Rezoning Transportation Analysis

Petition Number: 2020-007

General Location Identifier: Tax ID 11123334

Date	Description
03-24-20	First Review
06-29-20	Second Review

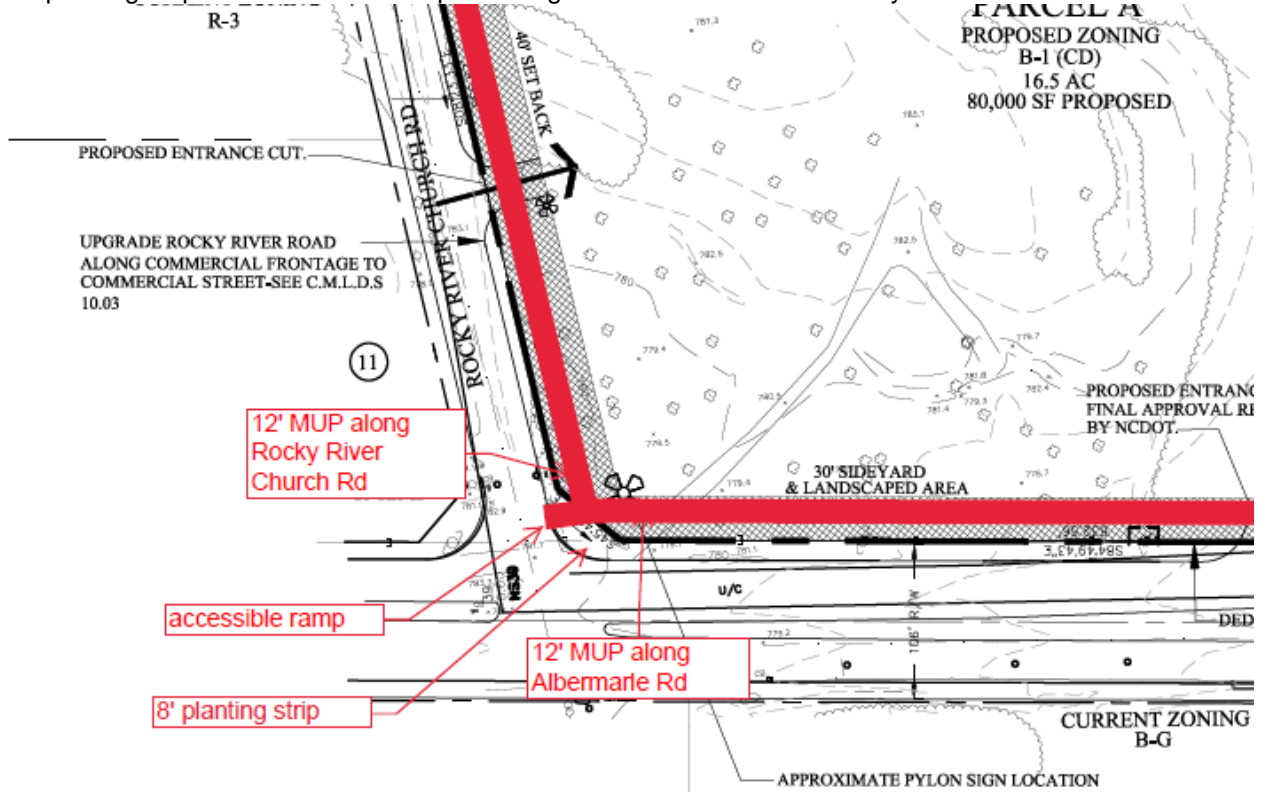
3. The petitioner should revise the site plan and conditional note(s) to commit to dedicate a minimum of 50 feet of right-of-way from the Albemarle Road centerline, per Chapter 12 of the Zoning Ordinance requirements for a Charlotte Regional Transportation Planning Organization (CRTPO) classified major thoroughfare. The site plan should label and dimension the right-of-way from the road centerline.
